### STAFF RECOMMENDATION 1611 Fatherland Ave May 17, 2017

**Application:** New construction – outbuilding and Setback determination  
**District:** Lockeland Springs-East End Neighborhood Conservation Zoning Overlay  
**Council District:** 06  
**Map and Parcel Number:** 19514000500  
**Applicant:** Anna & Erwin Herceg  
**Project Lead:** Jenny Warren, [jenny.warren@nashville.gov](mailto:jenny.warren@nashville.gov)

**Description of Project:** Construction of a new outbuilding with a side setback determination.

Site: <b>1611 Fatherland St.</b>	Drawing:	Project: <b>shed</b>	Drawn: <b>Anna</b>	Notes:  <b>Anna &amp; Erwin Herceg 1611 Fatherland Street, Nashville, TN 37206 615-428-9763</b>
<b>Backyard shed</b>	Scale: <b>1/2":1'0"</b>	Date: <b>04/13/2017</b>

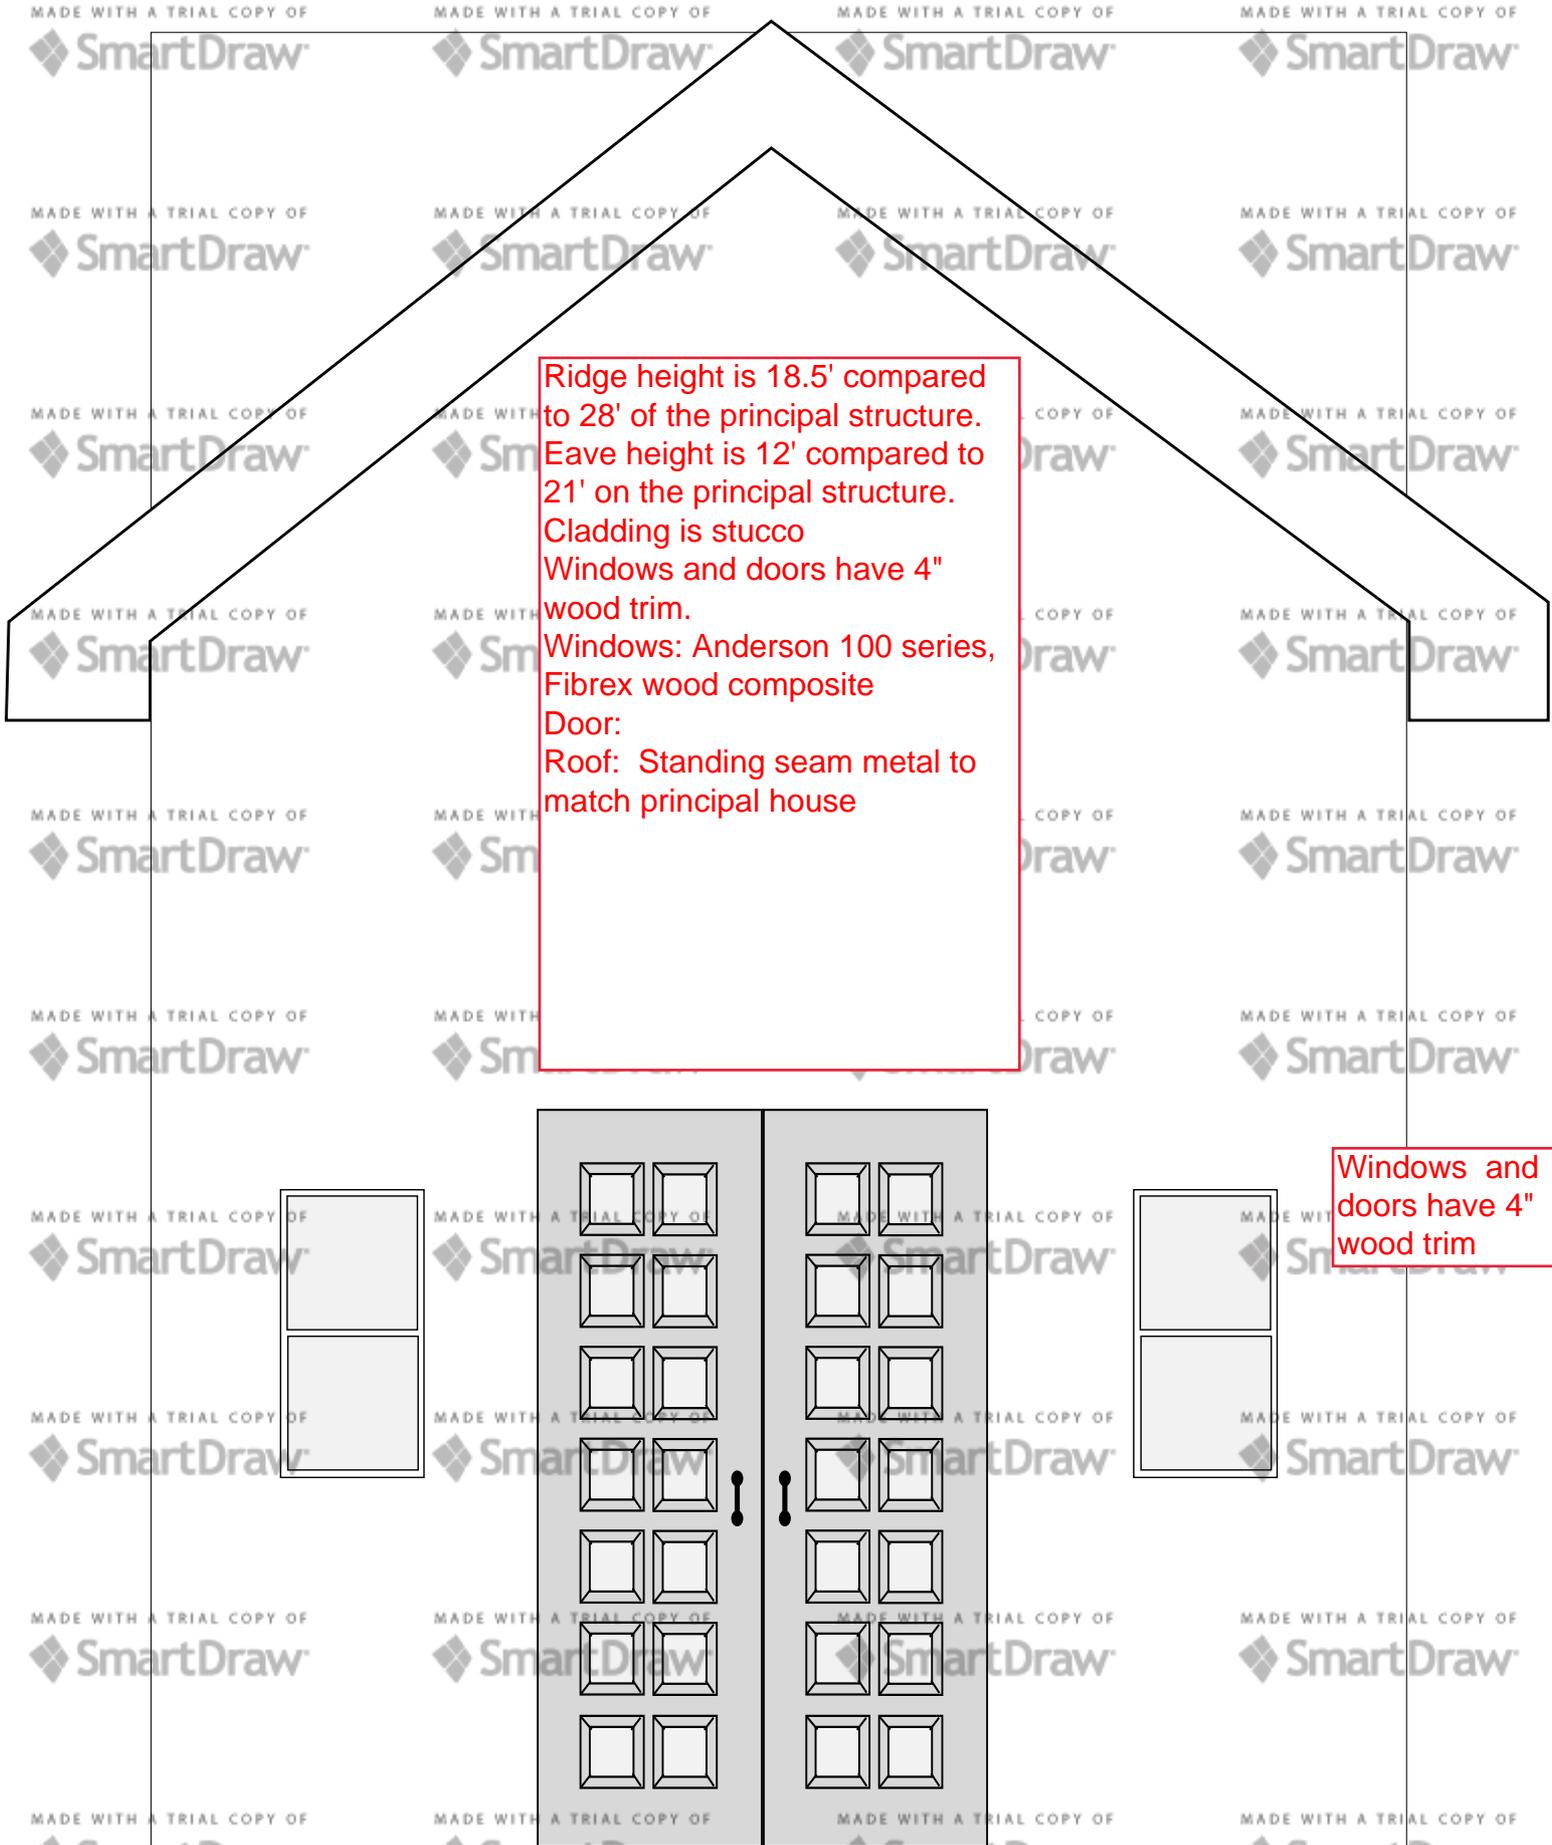
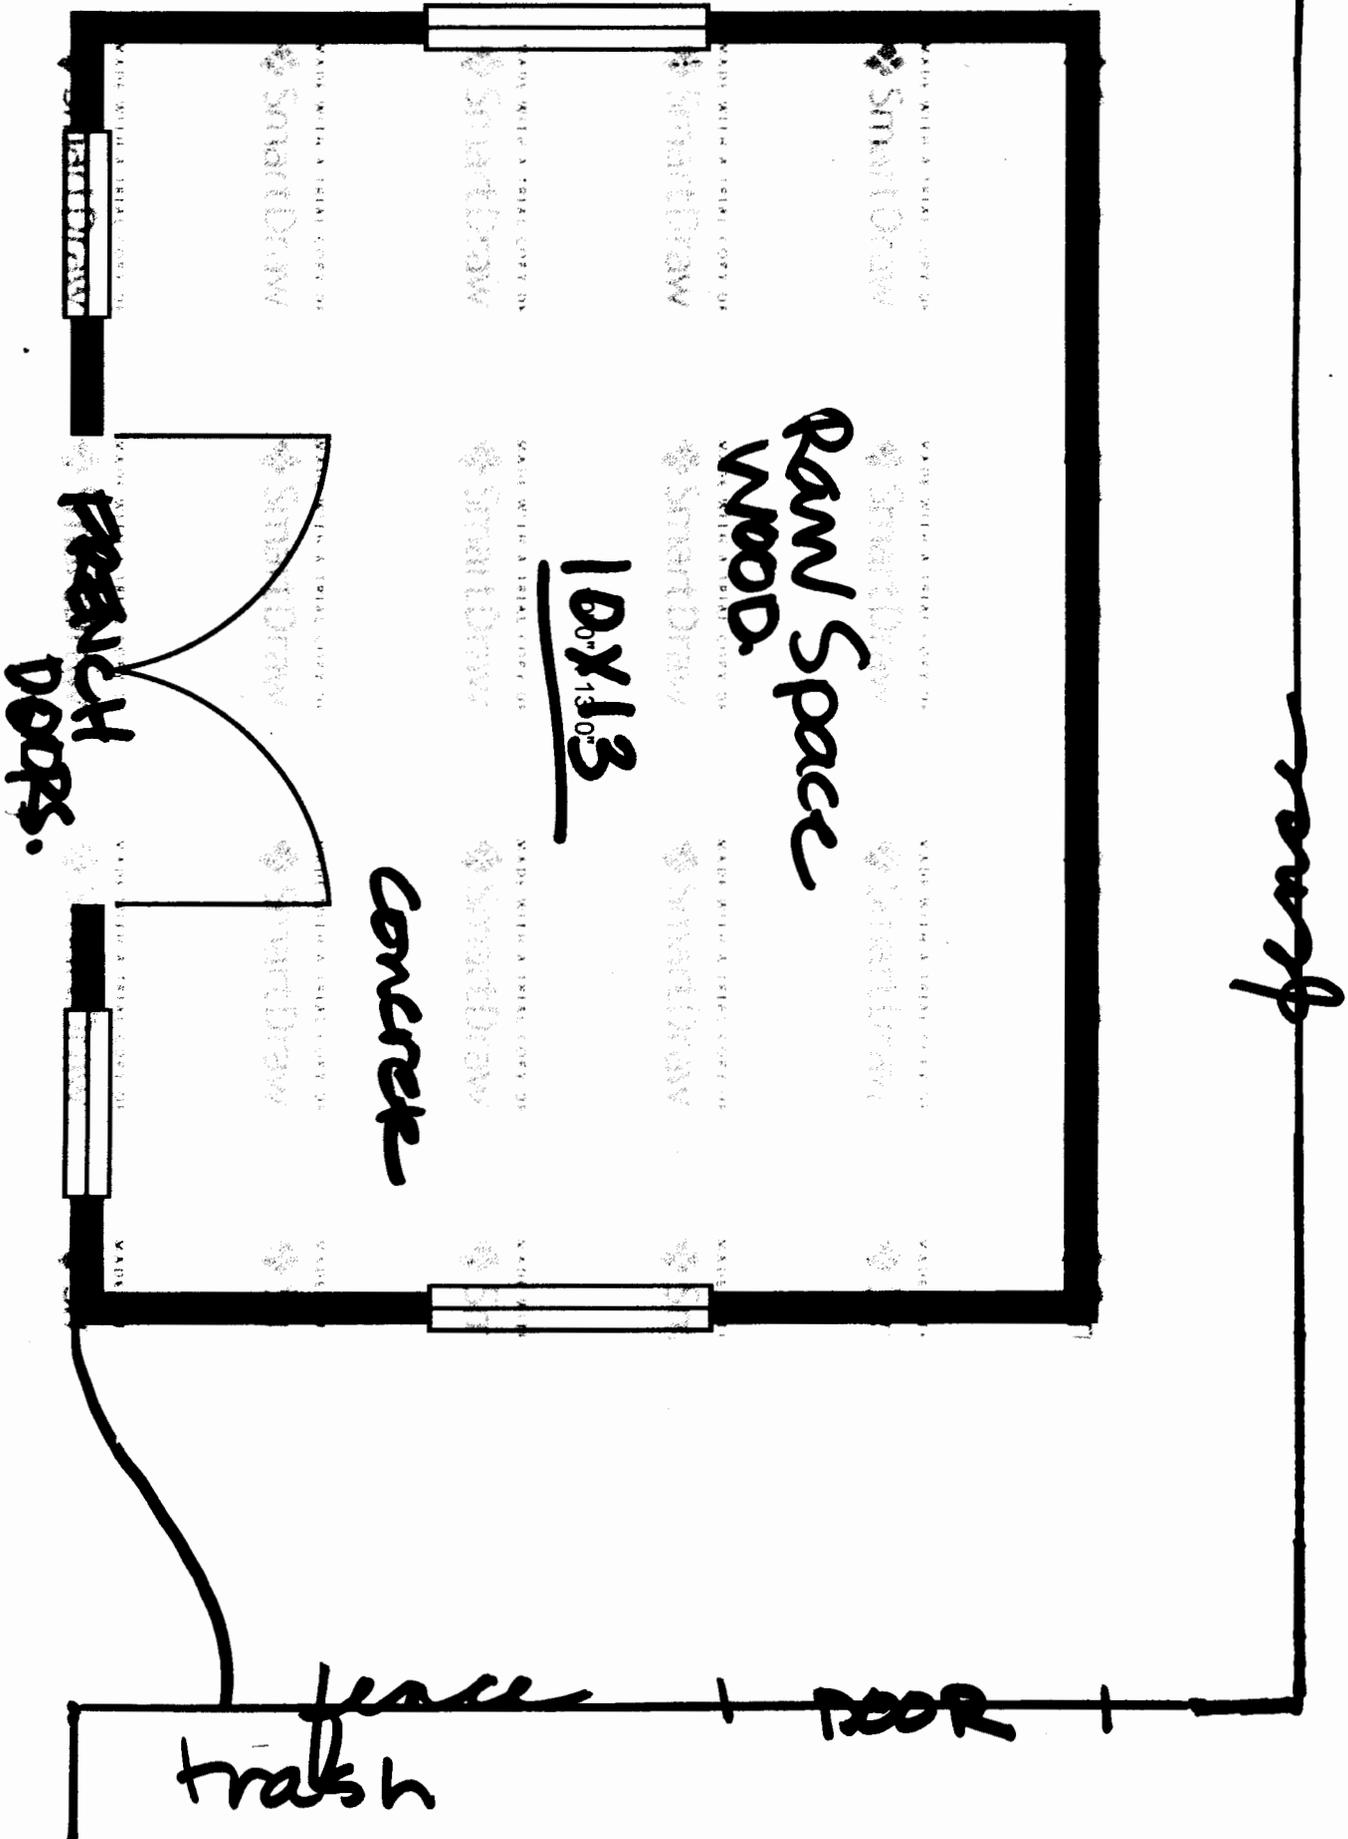
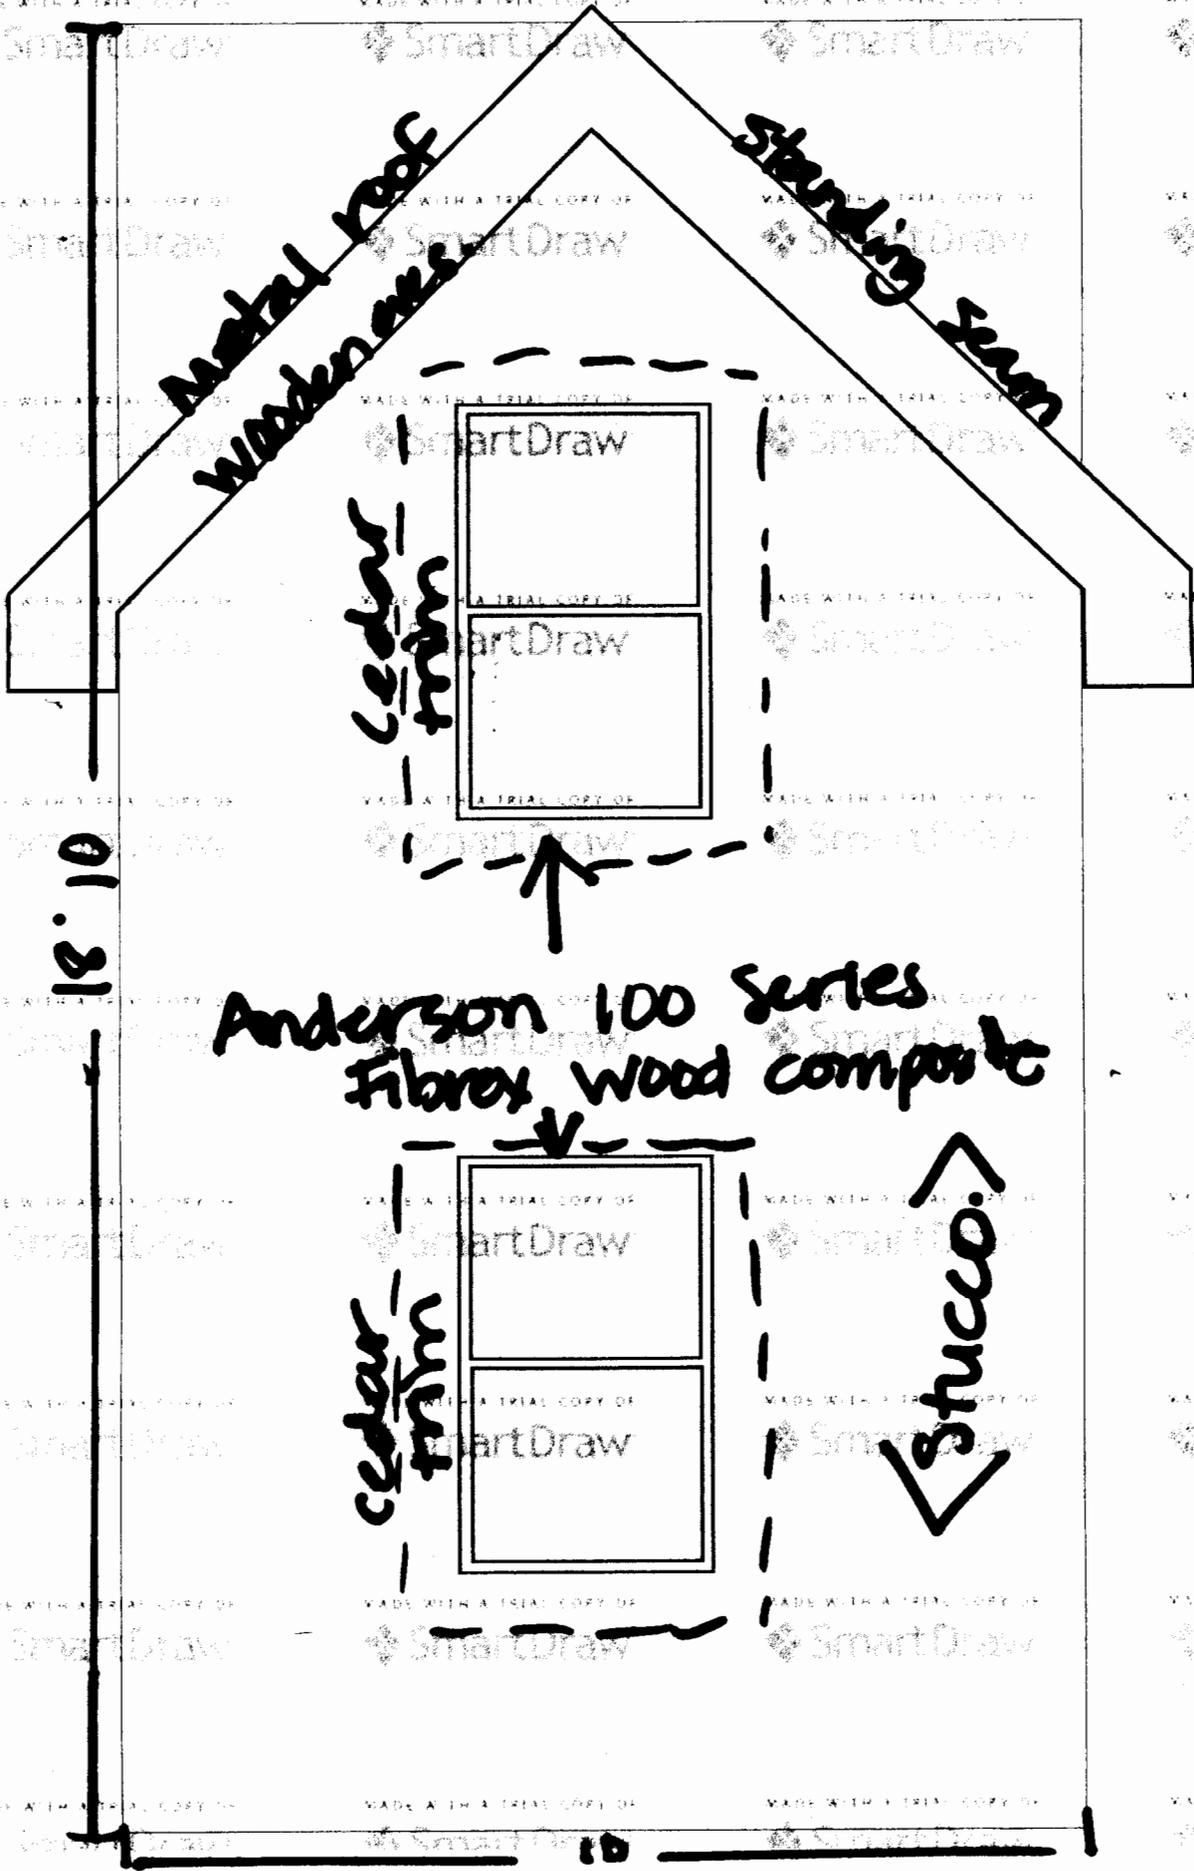
With staff's final approval of the stucco finish, staff finds that the known materials meet Section II.B.8 of the design guidelines.

Ridge height is 18.5' compared to 28' of the principal structure.  
Eave height is 12' compared to 21' on the principal structure.  
Cladding is stucco  
Windows and doors have 4" wood trim.  
Windows: Anderson 100 series,  
Fibrex wood composite  
Door:  
Roof: Standing seam metal to match principal house

1. Staff approve the stucco color and texture.
